# NEW EZ SQUEEZE™ IMPROVEMENTS

NOW ON ALL MODELS OF THE EZ SQUEEZE™

## Old Handle Vs. New Handle

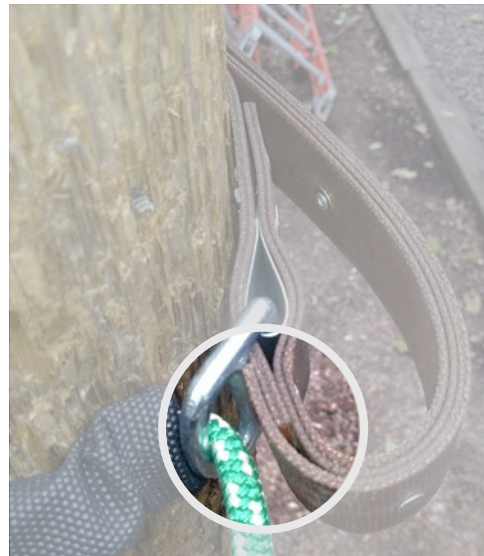
The new handle has been reinforced to provide more rigidity, which makes ascending and descending easier.

Reinforced handle  
for more rigidity.
